Access Compliance Report

Public Rights-of-Way

(Pedestrian Signals)

Intersection ID: N/A	Main Street:	Cross Street: N/A	Location: N/A
ADA ID: A7FC75172C46	Signal Type: Two Push Buttons-APS	Overall Compliance: No	Severity Score: BTN 1:N/A BTN 2: N/A No BTN: N/A
Codes/Mitigation Info/Possible Solution		Field Measurements/Component Compliance

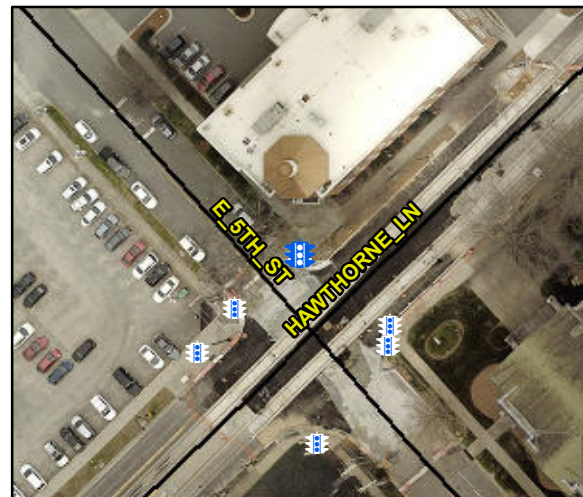
Possible Solutions: Remove & Replace
Replace APS Button With New APS Button.
Remove and Replace Clear Space. Replace
Signal Push Button With APS Button on New
Post. Remove & Relocate Sign.

PROW/ADA: R404.2, R404.3, R406.2,
R404.7.3, , TMUTCD 4e.08
